工程指示 / 要求簡箋(E.I.)

工程指示編號：EI / 5527 / 22 (原 EI 5272) 修改版次：C

工程名稱：將軍澳日出康城 LP 11

工程項目：幕牆 大貨單元件加工圖

858工程公企、母企胶条配套测试

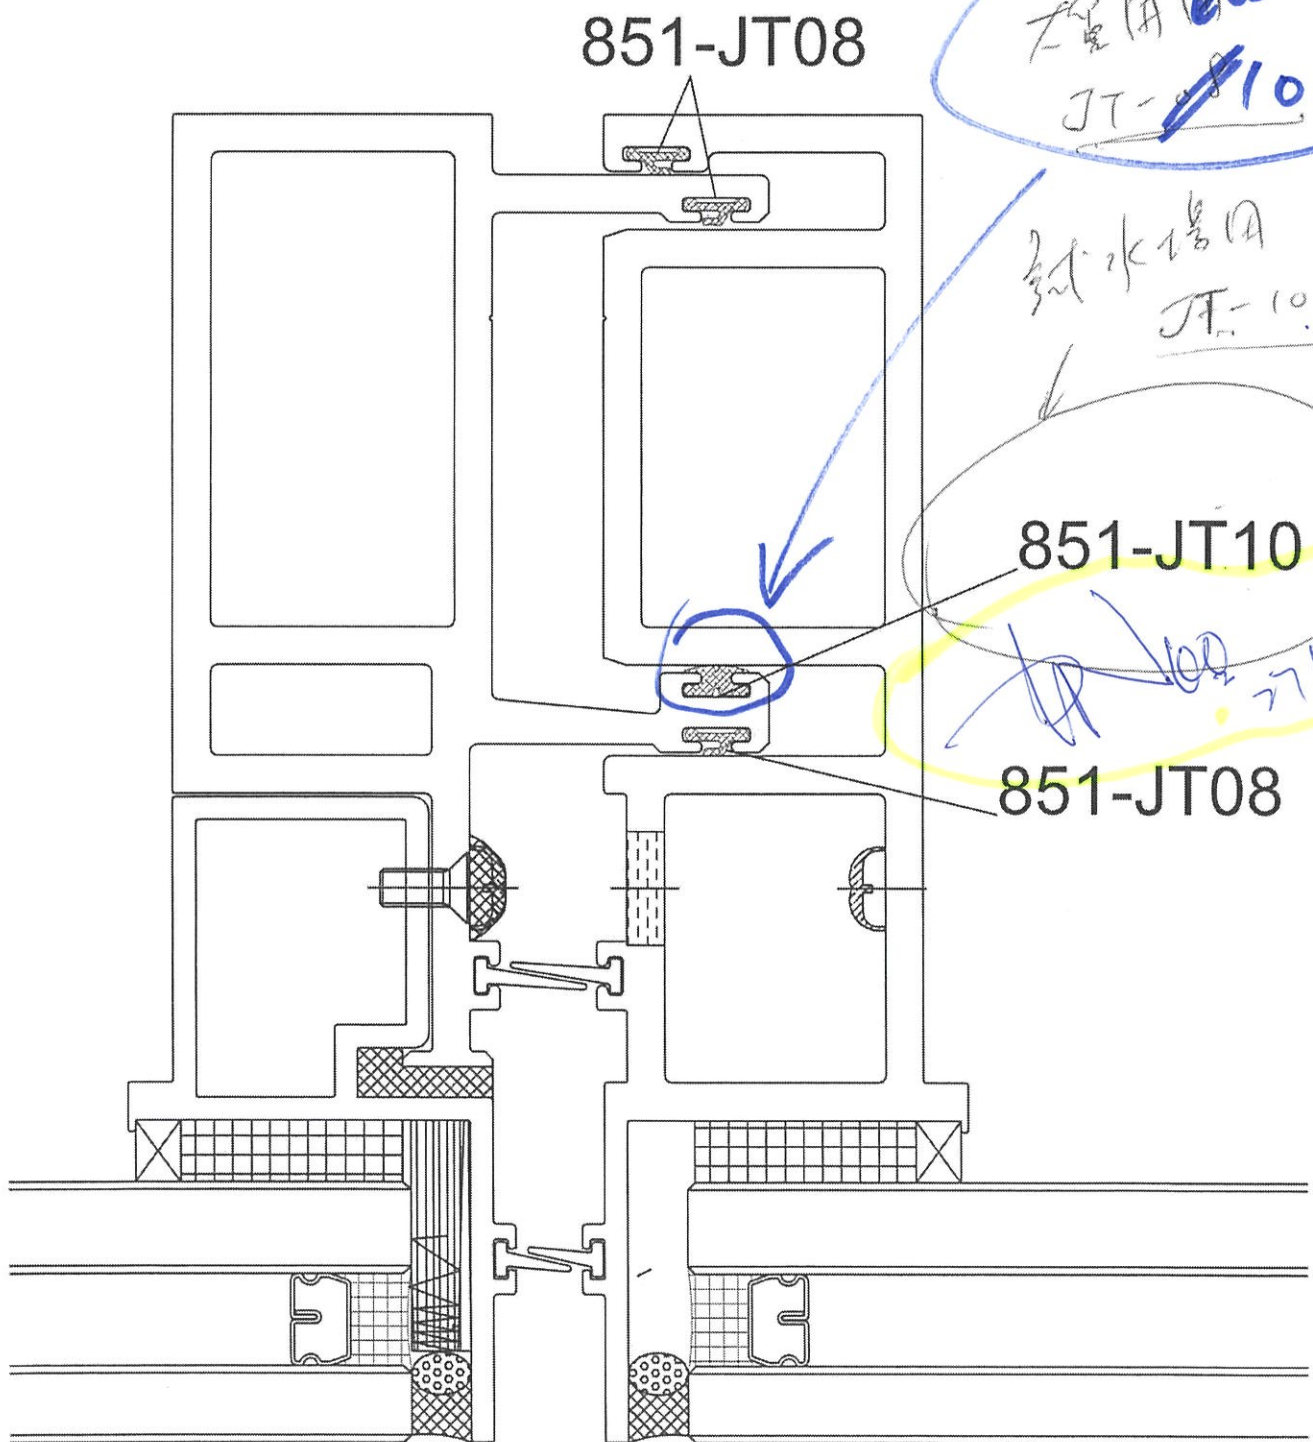
依拆图全用08，太松

如图示配套，略紧，但可以装。

J858单元幕墙胶条位置图

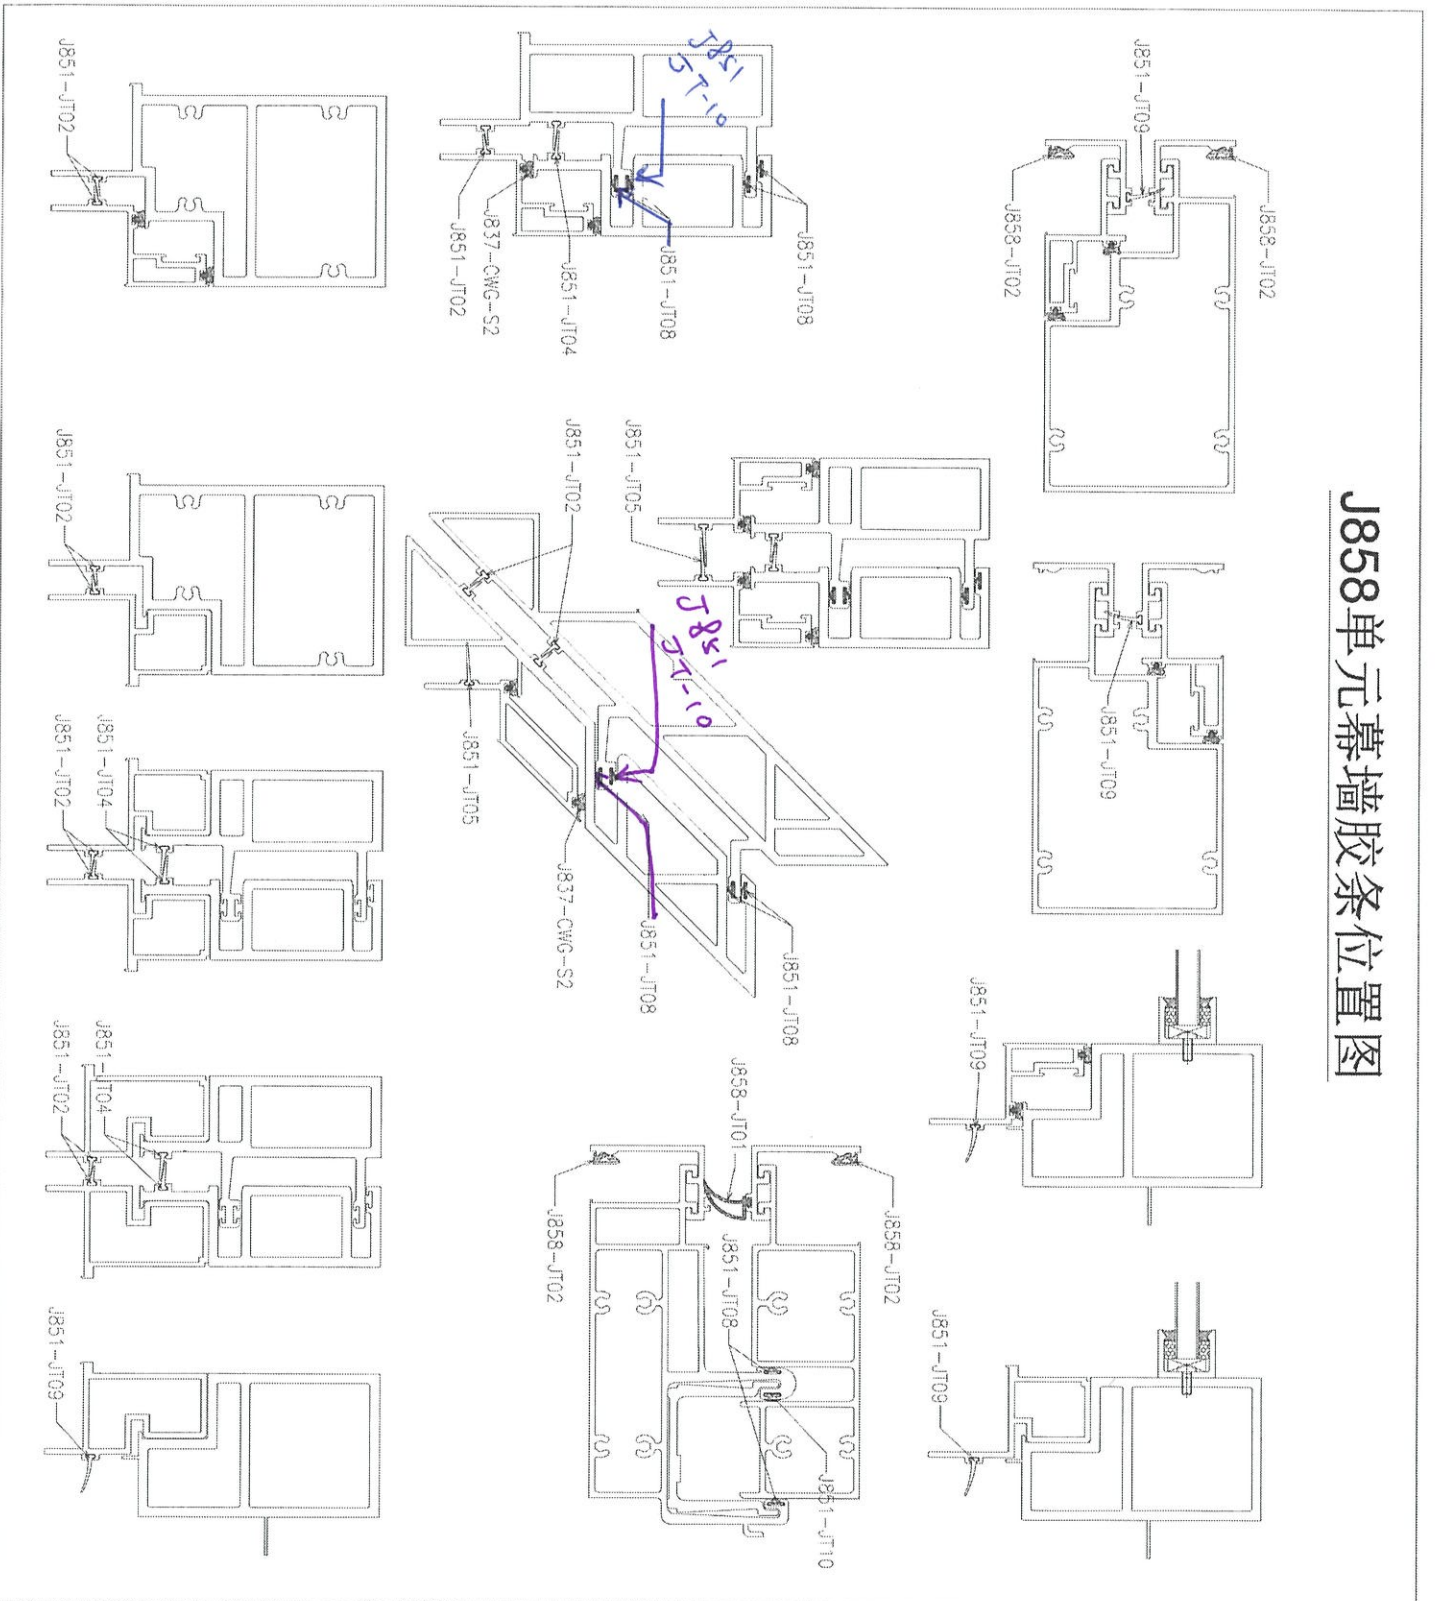
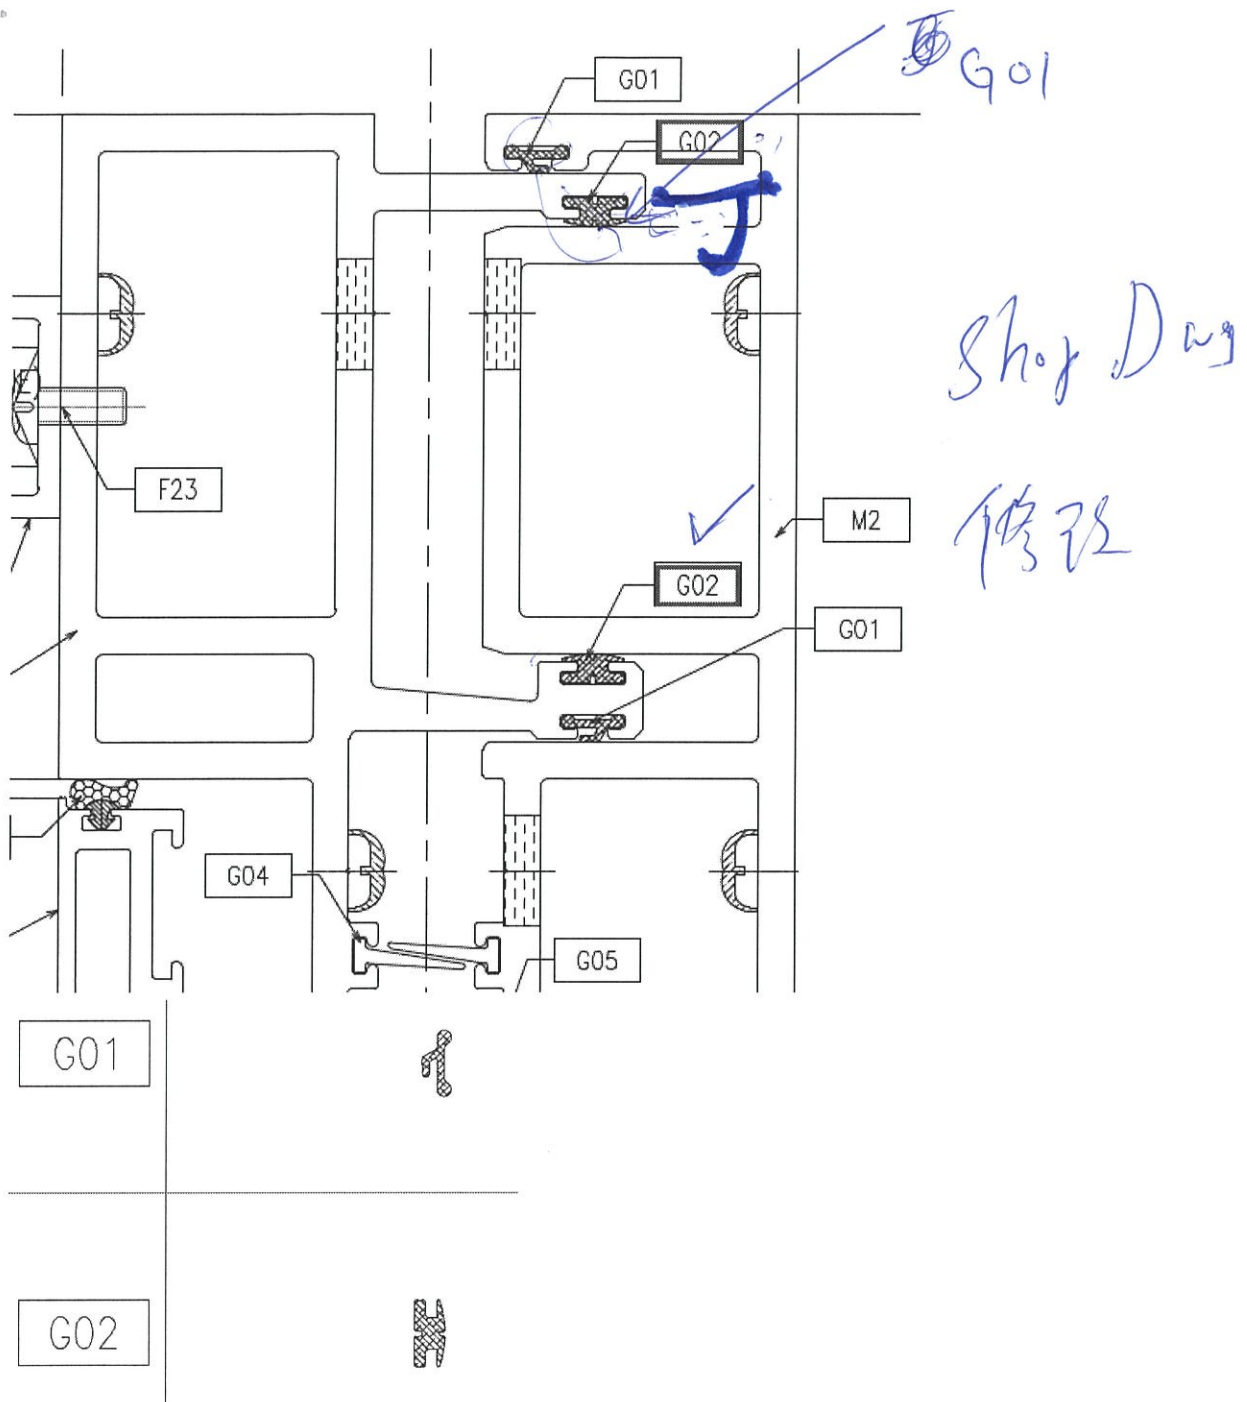
The onsite pre- assembled gasket surface is observed to below the extrusion surface which cannot performance as a reliable water barrier.

Shop Drawing:

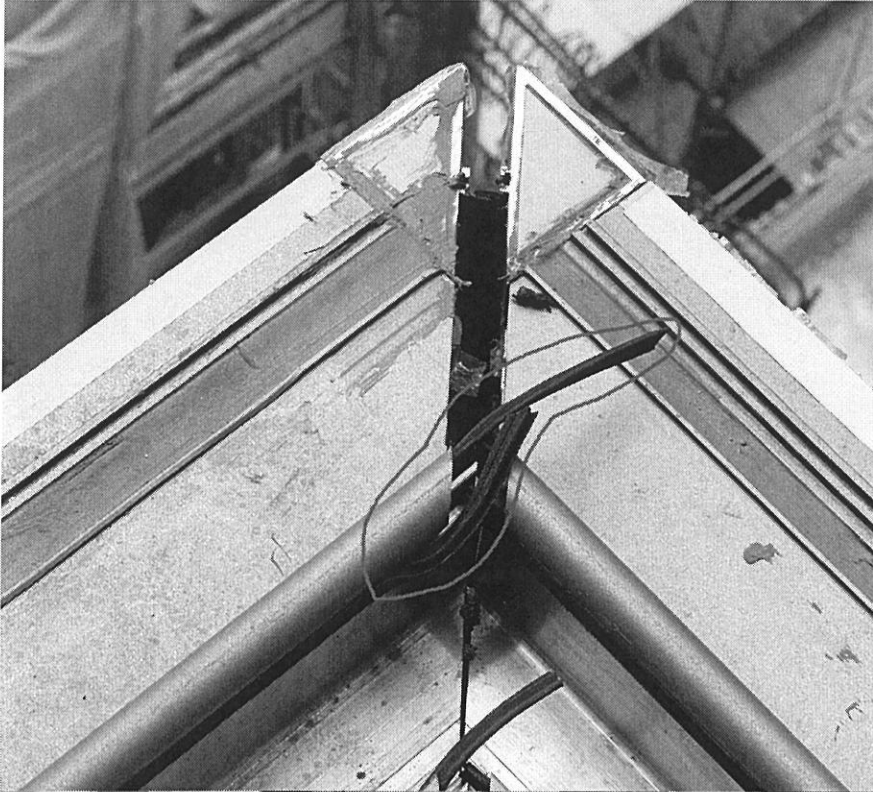
1. Mullion gasket type revise

The pre-assembled gaskets on male mullion is observed to be not in line with shop drawing design, which may have influence on the whole system water tightness performance.

Please provide clarification and:

- a. Replace the gasket on installed panels.
- b. Double check for other onsite stored units and revise is necessary.
- c. Carry out the QA/QC method at factory panel accurate fabrication work to guarantee all works are in line with approved shop drawings.
